INVITATION TO BID 2026-01
CITY OF PARKER
2025 ROADWAY RESURFACING PROJECT

**ADDENDUM NO. 4
NOTICE TO BIDDERS**

Issued September 29, 2026

Sheet No.
C2.4

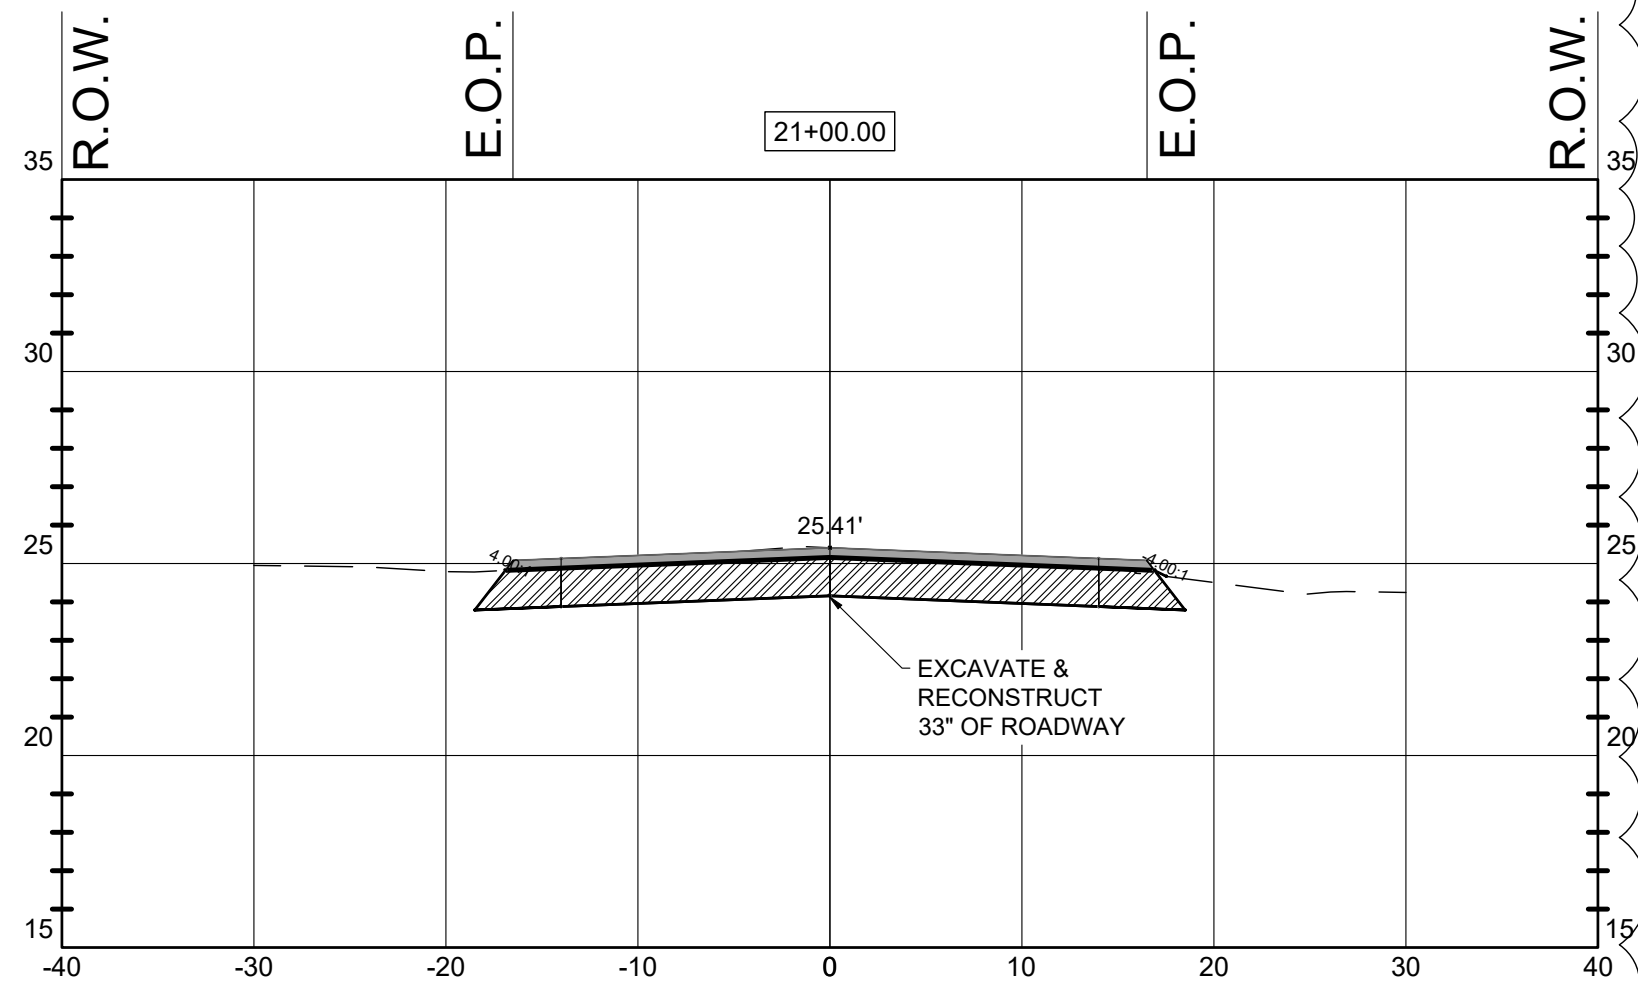
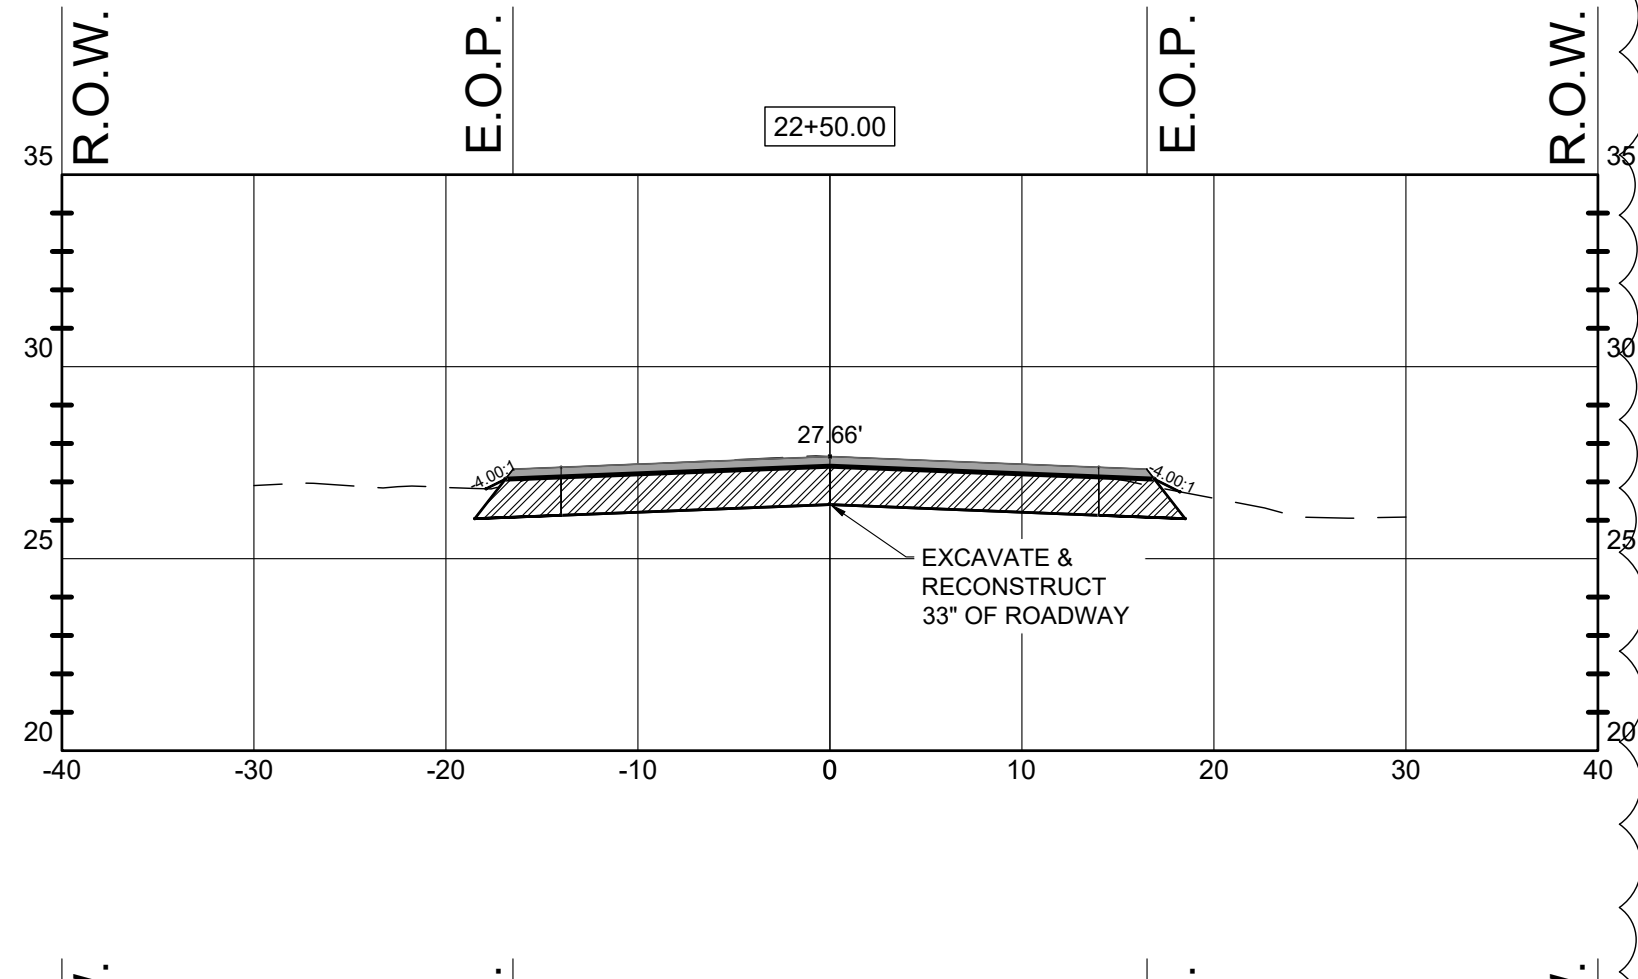
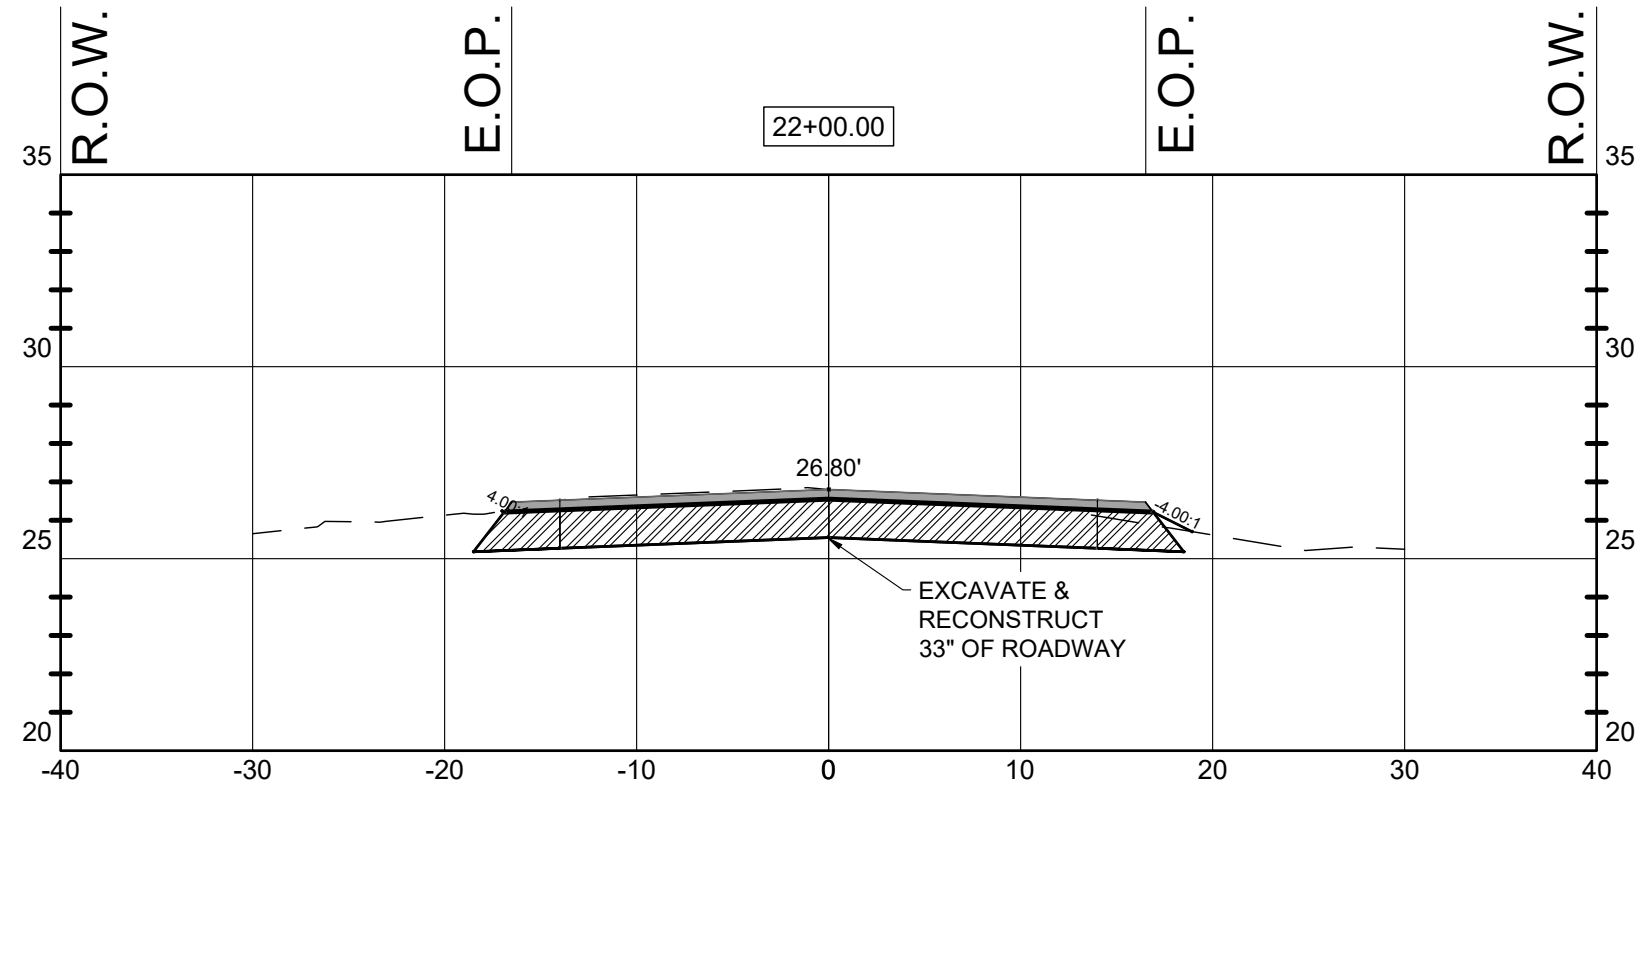
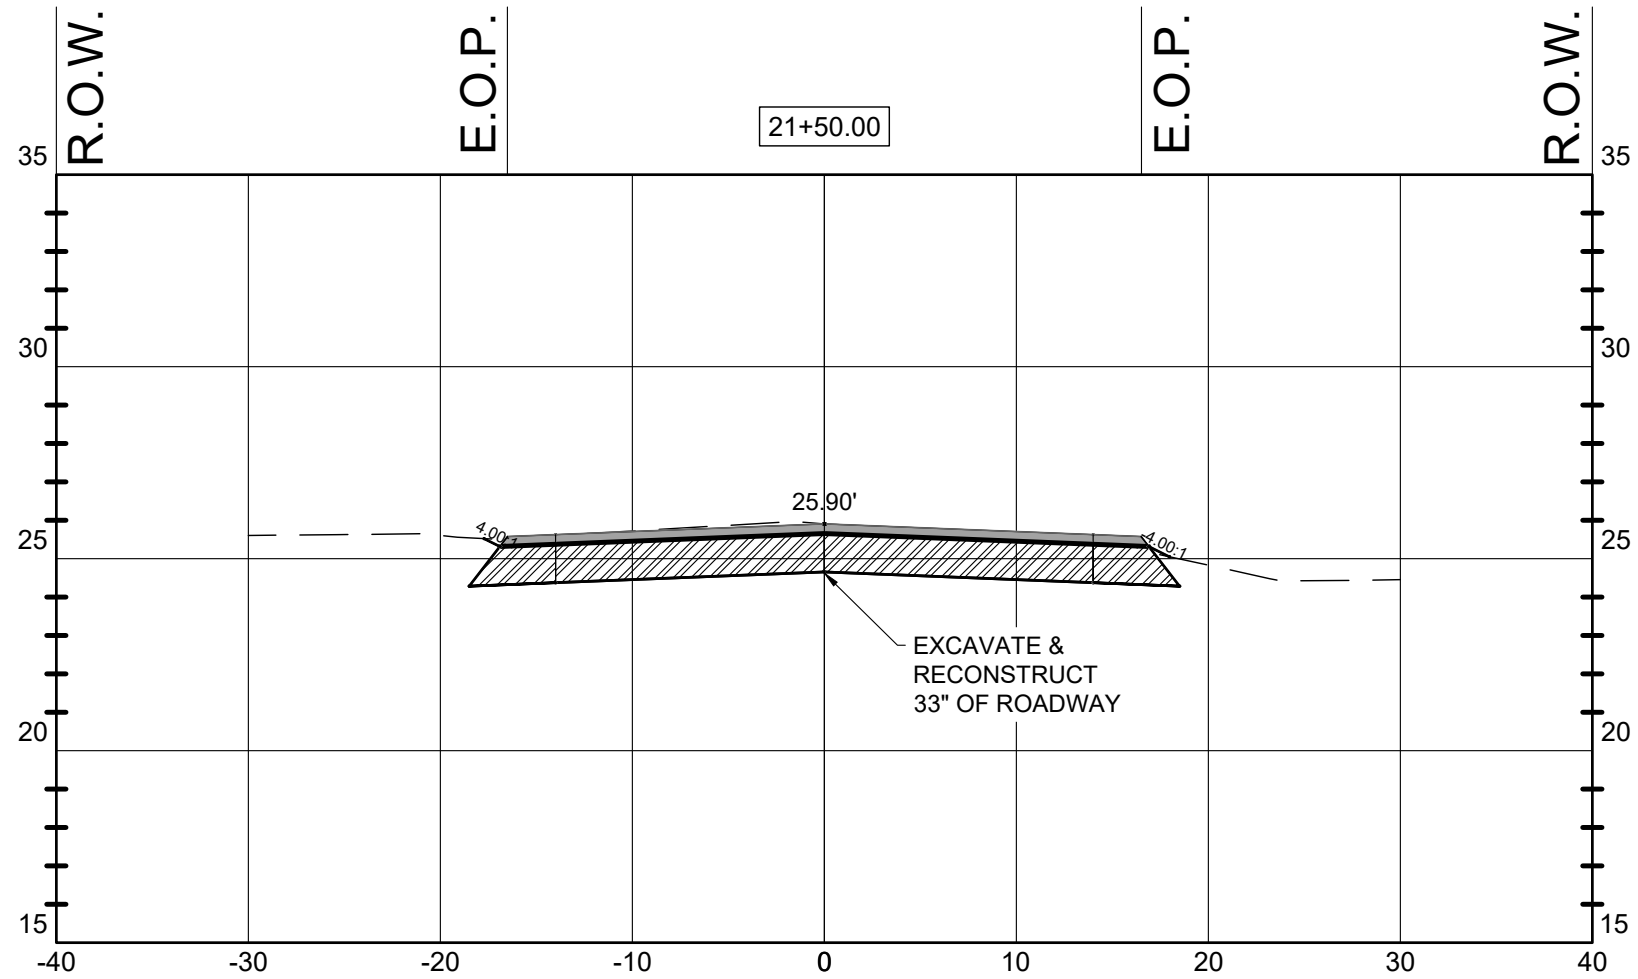
- h. Sheets C2.2 through C2.10 – Hwy 22A (Bob Little Road) Sections: Sections have been modified within each sheet and a note has been **ADDED** to each sheet which states, **“CONTRACTOR TO ADD COMPACTED FILL ALONG THE EDGE OF THE ROADWAY IF THE DROPOFF IS MORE THAN 1.0” AND SHALL BE PLACED AT A SLOPE OF 1:4 IN ACCORDANCE WITH 2026 OR CURRENT EDITION OF FDOT STANDARD INDEX 570-010.”**

NOTES:
CONTRACTOR TO ADD COMPACTED FILL ALONG THE
EDGE OF THE ROADWAY IF THE DROPOFF IS MORE
THAN 1.0' AND SHALL BE PLACED AT A SLOPE OF 1:4
IN ACCORDANCE WITH 2026 OR CURRENT EDITION
OF FDOT STANDARD INDEX 570-010.

Sheet No.
C2.12

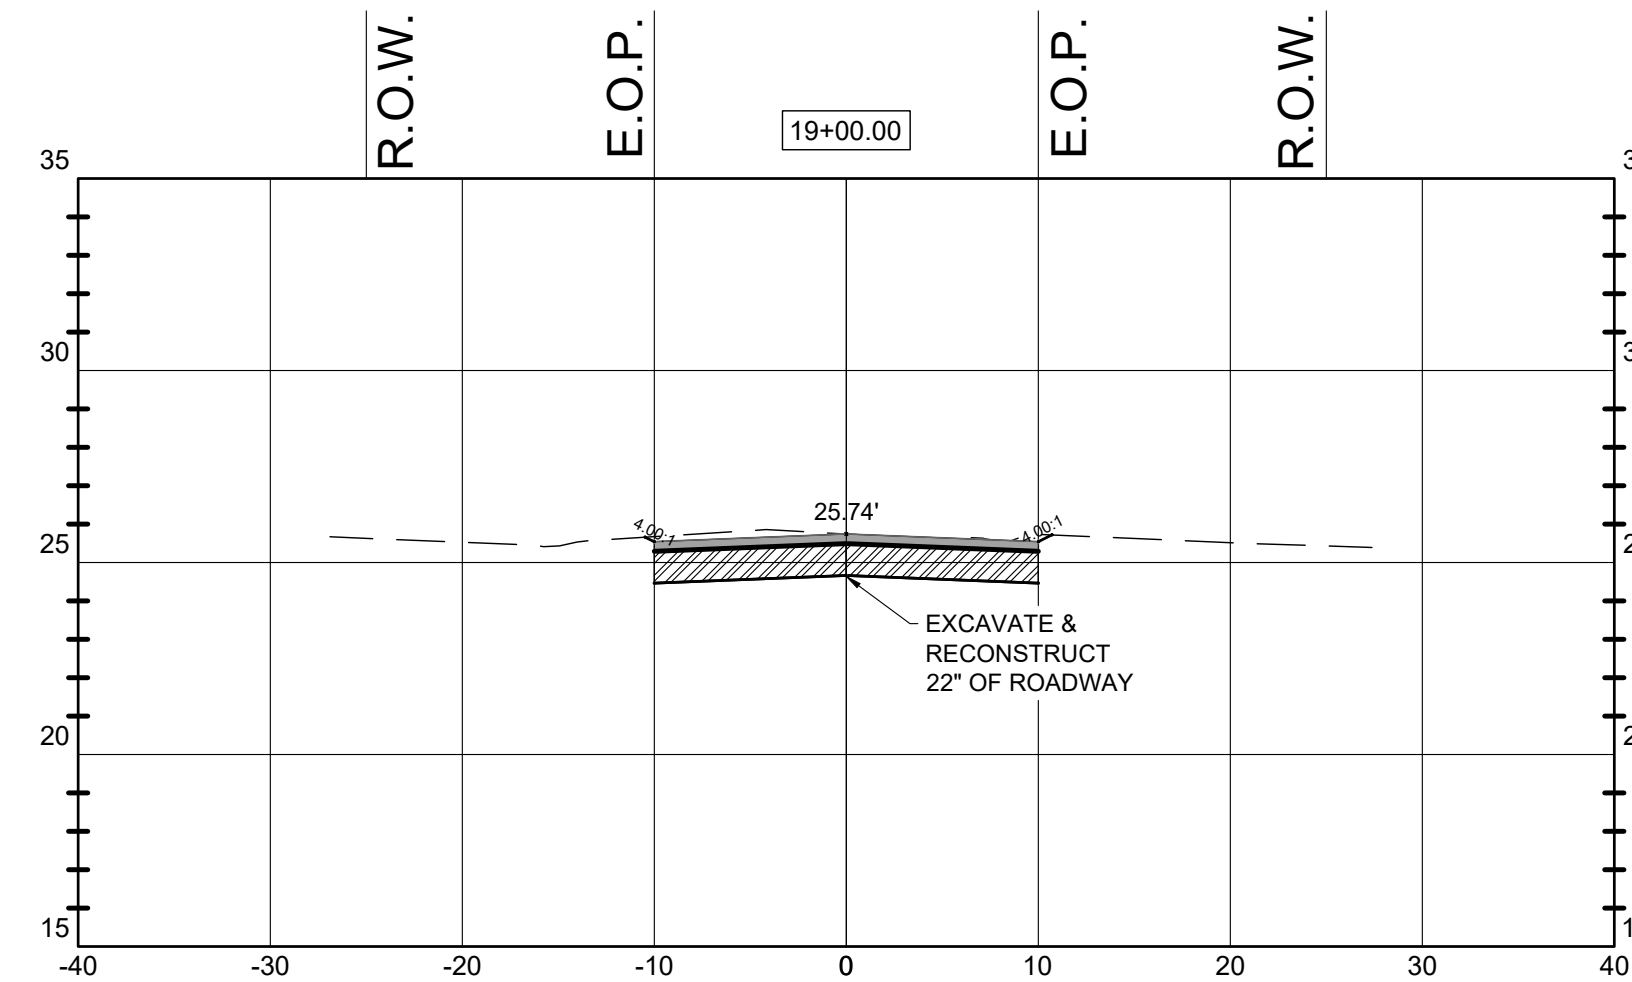
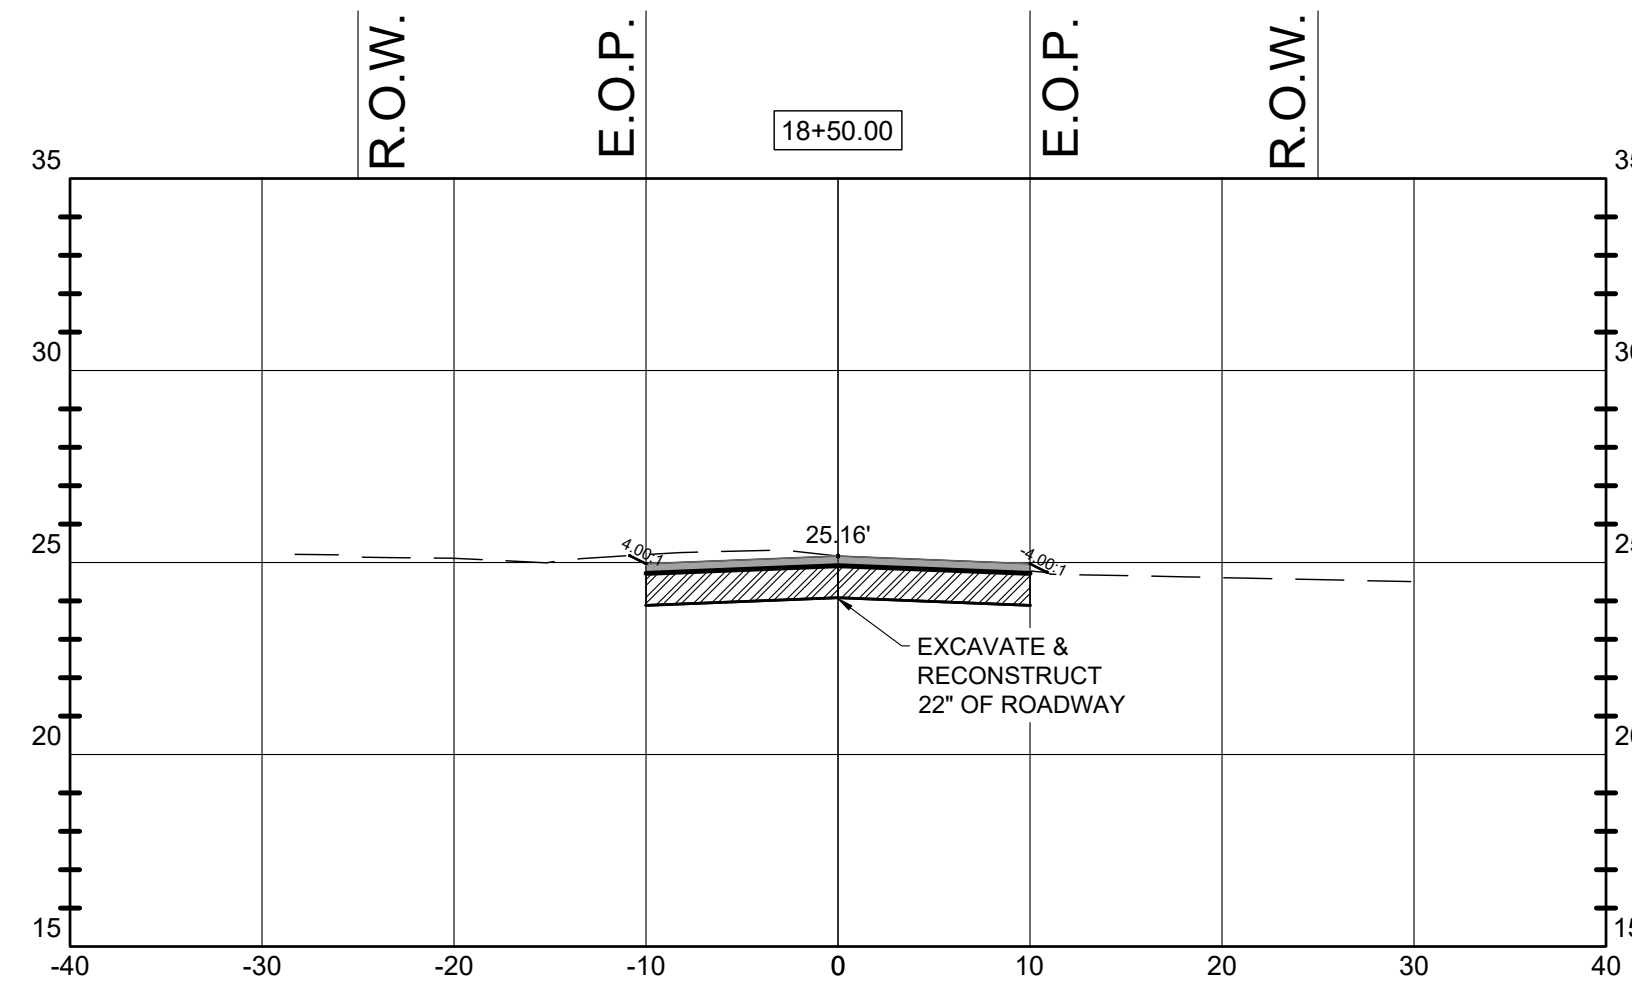
- i. Sheets C2.11 through C2.15– N. 9th Street Sections: Sections have been modified within each sheet and a note has been **ADDED** to each sheet which states, **“CONTRACTOR TO ADD COMPACTED FILL ALONG THE EDGE OF THE ROADWAY IF THE DROPOFF IS MORE THAN 1.0” AND SHALL BE PLACED AT A SLOPE OF 1:4 IN ACCORDANCE WITH 2026 OR CURRENT EDITION OF FDOT STANDARD INDEX 570-010.”**

NOTES:
CONTRACTOR TO ADD COMPACTED FILL ALONG THE EDGE OF THE ROADWAY IF THE DROPOFF IS MORE THAN 1.0" AND SHALL BE PLACED AT A SLOPE OF 1:4 IN ACCORDANCE WITH 2026 OR CURRENT EDITION OF FDOT STANDARD INDEX 570-010.
